02 AUG 1996  
PLANS NOT APPROVED  
ON BEHALF OF THE COUNCIL

Project  
**57 Coldhurst Terrace NW6**  
 Loft Conversion into a Bedroom

Scale: 1:20 & 1:50      Date: JAN 1996      Dwg No: COL/96/1B

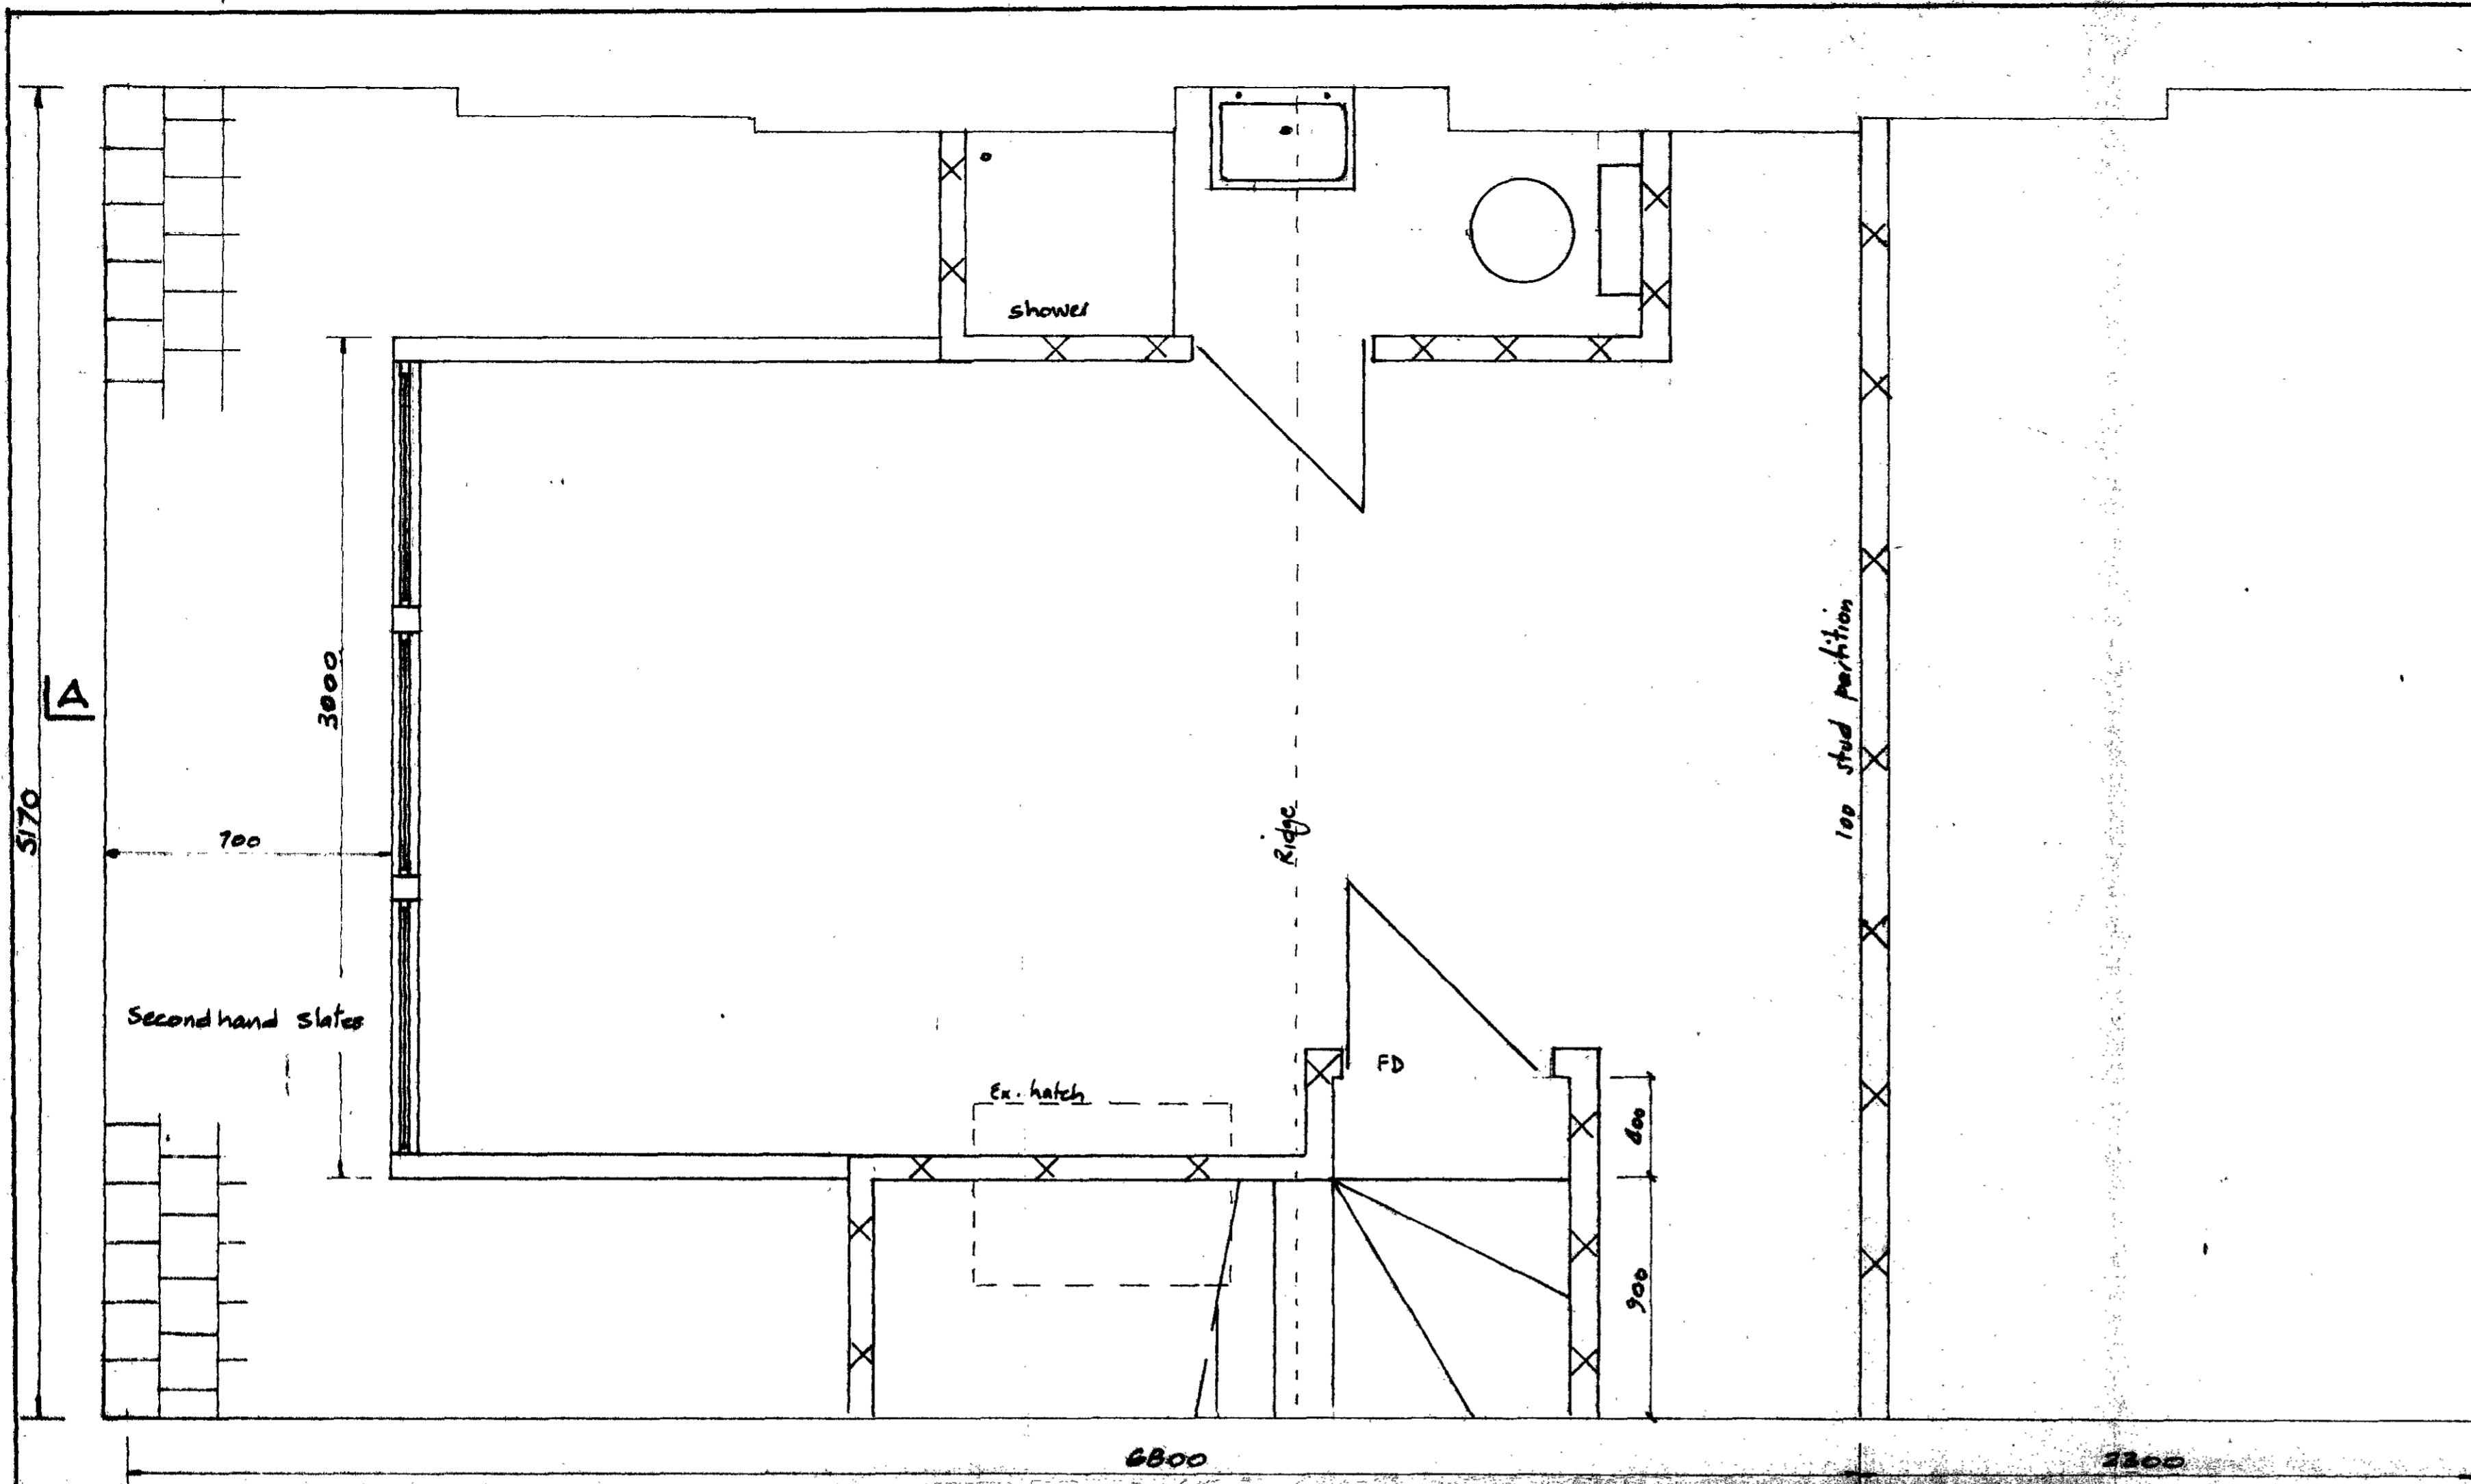
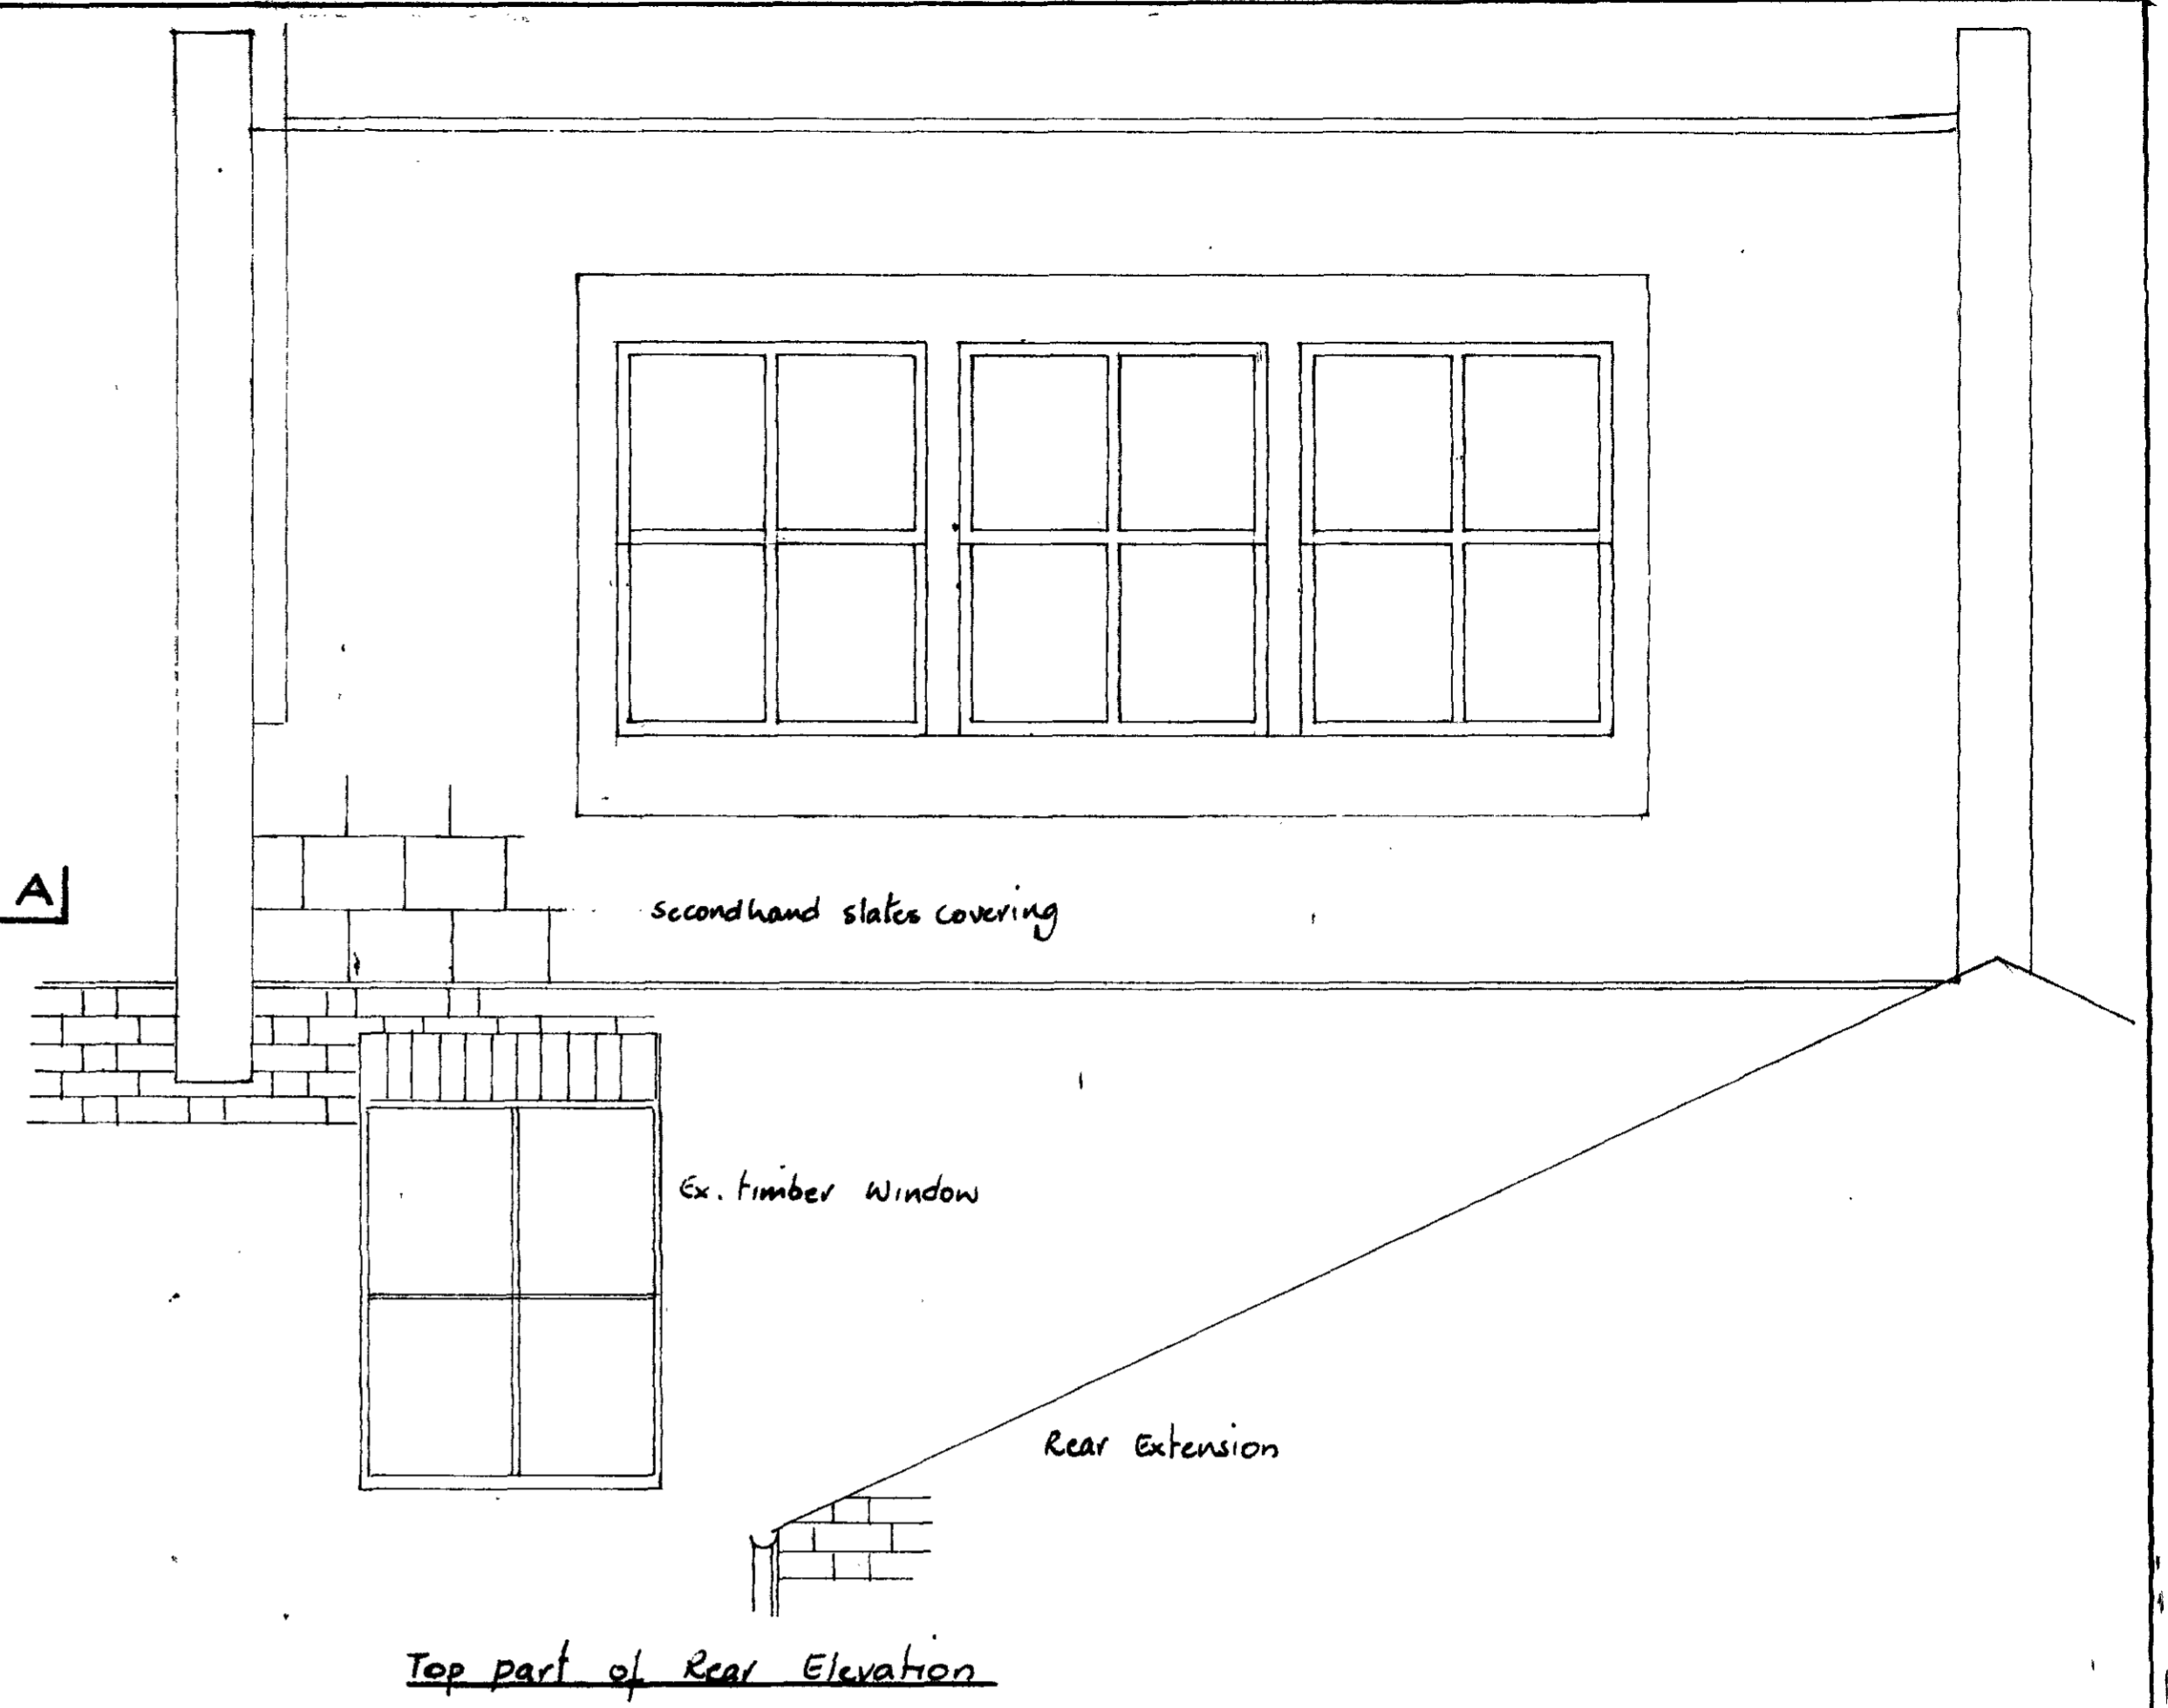
Rev	Date	Description
B	6.6.96	9/8 width of dormer revised to 3000
A	26.4.96	Revised to comply LA Planning Dept
